SUBJECT: ISSUANCE OF AMENDMENT NO.23 TO FACILITY OPERATING LICENSE NPF-68
AND AMENDMENT NO. 4 TO FACILITY OPERATING LICENSE NPF-81 - VOGTLE
ELECTRIC GENERATING PLANT, UNITS 1 AND 2 (TACs 73125/73126)

The amendments revise requirements regarding containment tendon surveillance.

SAFETY EVALUATION BY THE OFFICE OF NUCLEAR REACTOR REGULATION
RELATED TO AMENDMENT NO. 23 TO FACILITY OPERATING LICENSE NPF-68
AND AMENDMENT NO. 4 TO FACILITY OPERATING LICENSE NPF-81
GEORGIA POWER COMPANY, ET AL.
DOCKET NOS. 50-424 AND 50-425
VOGTLE ELECTRIC GENERATING PLANT, UNITS 1 AND 2

FIGURE 3.6-1

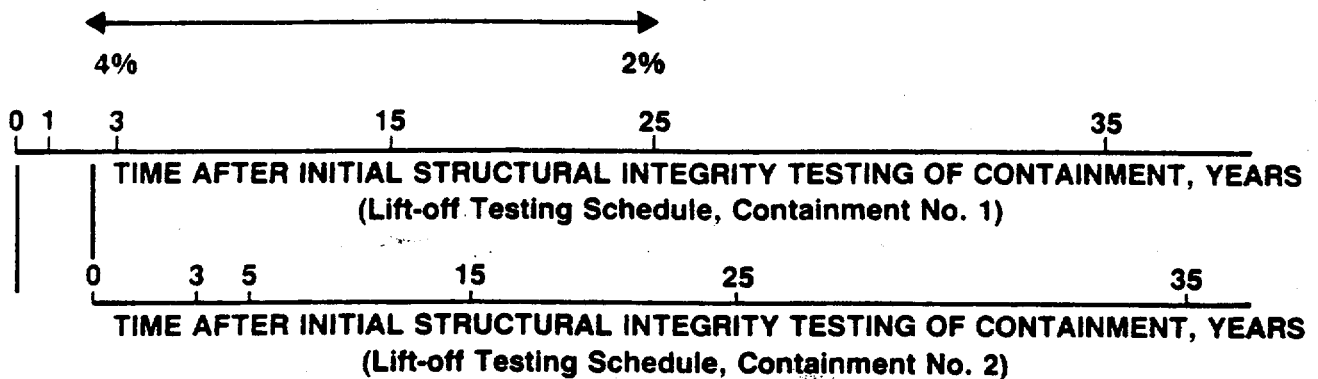
The structural integrity of the prestressing tendons of the containments shall be demonstrated at the end of 1, 3, and 5 years following the initial containment vessel structural integrity test and at 5-year intervals thereafter. For combined inspections of two containments in a plant, lift-off testing will be performed in accordance with the inspection schedule shown in Figure 3.6-1.

be detensioned on Unit 1 each time lift-offs are performed on Unit 1 per Figure 3.6-1. One tendon shall be detensioned on Unit 1 each time lift-offs are performed on Unit 2 per Figure 3.6-1. A randomly selected tendon shall be essentially completely detensioned in order to identify broken or damaged wires and determining that over the entire length of the removed wire sample (which should include the broken wire if so identified) that:

- a. The containments are identical in all aspects such as size, tendon system, design, materials of construction, and method of construction. The tendon system for Unit 2 does not provide for detensioning. Detensioning can be performed only on the Unit 1 tendon system.
- b. The 1-year inspection for Unit 2 will consist of a visual inspection only. No lift-off testing will be performed on Unit 2 until the 3-year inspection.
- c. There is no unique situation that may subject either containment to a different potential for structural or tendon deterioration.
- d. The Unit 1 and Unit 2 surveillances may be performed back-to-back to facilitate detensioning of Unit 1 tendons during the Unit 2 surveillance.
- e. In order to perform back-to-back surveillances on Units 1 and 2, the Unit 1 10-year surveillance and the Unit 2 5-year surveillance are to be performed between 5/1/95 and 11/1/95.

SCHEDULE OF LIST-OFF TESTING FOR TWO CONTAINMENTS AT A SITE
